SHELL OIL COMPANY

REFINERY OPERATIONS BUILDING

A/C REVISIONS

June 3, 1987

PARTIAL MECHANICAL BASEMENT PLAN

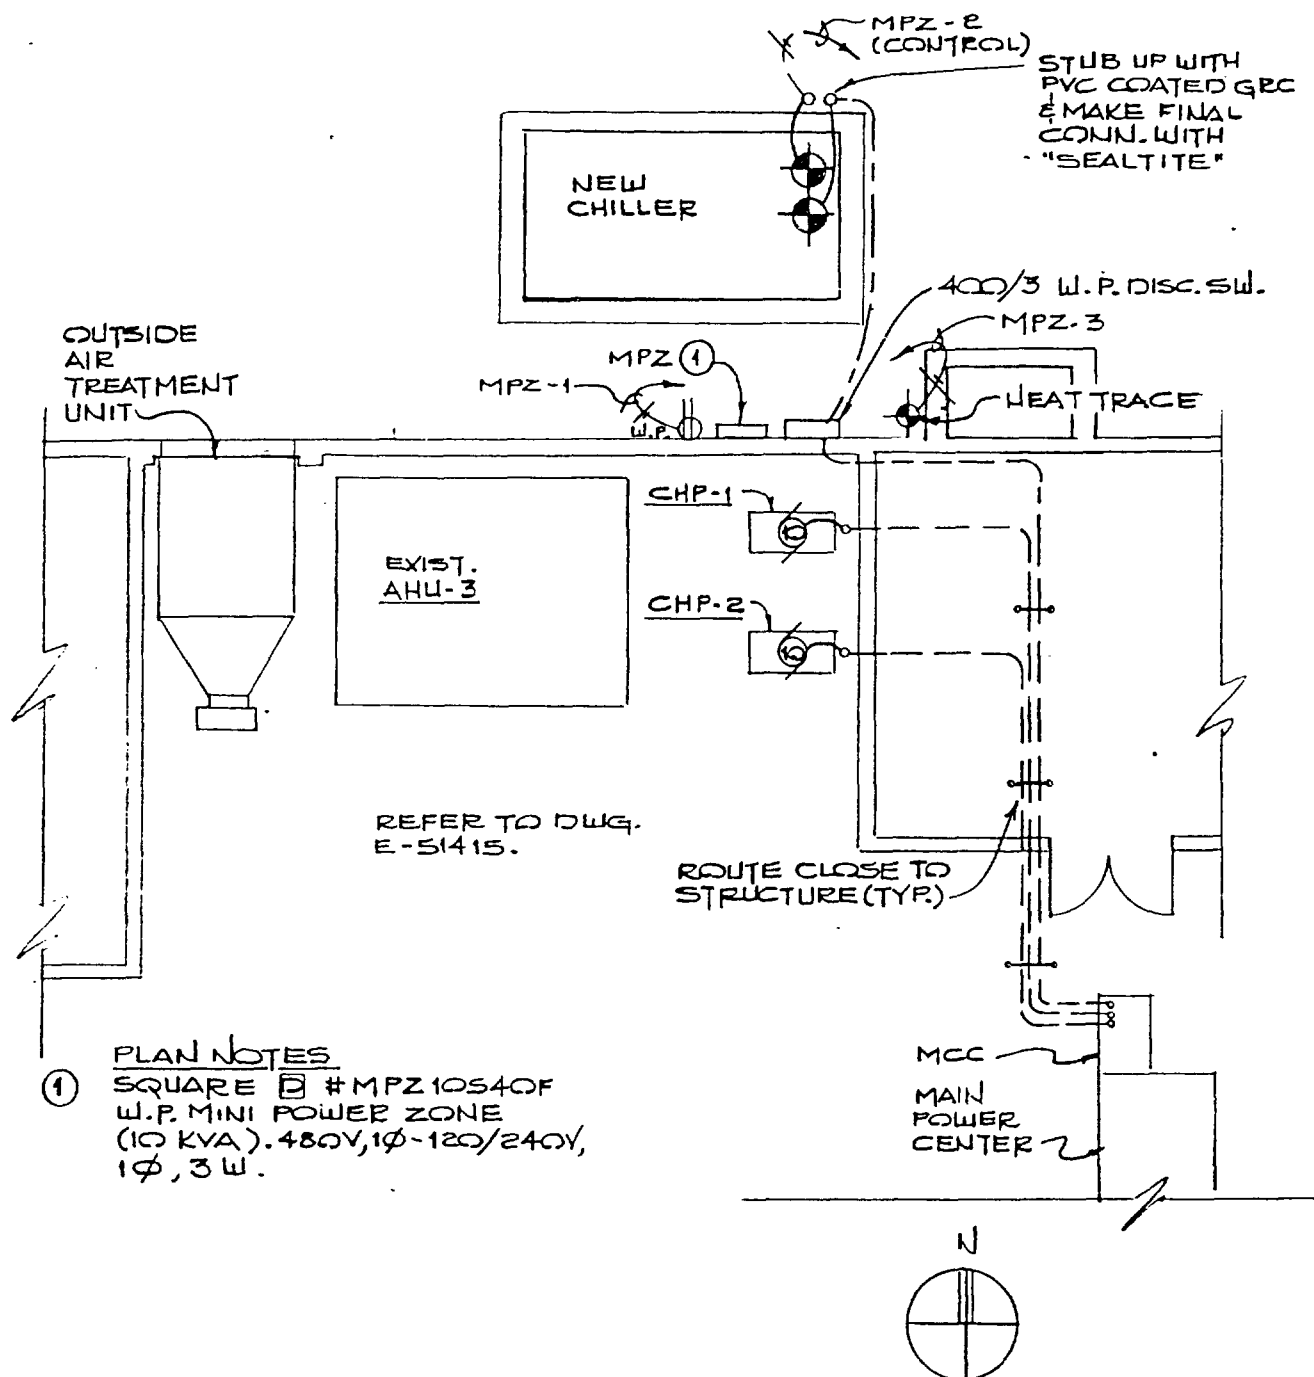
As requested by you, we have prepared the enclosed documents to locate the Air Cooled Packaged Chiller on the North side of the building, and indicate a single chiller in lieu of dual chillers. This change affected the Mechanical and Electrical Scope of Work, and will reduce our estimated construction cost by approximately Eighty Thousand Dollars (\$80,000.00) as outlined in the enclosed Cost Estimate. .
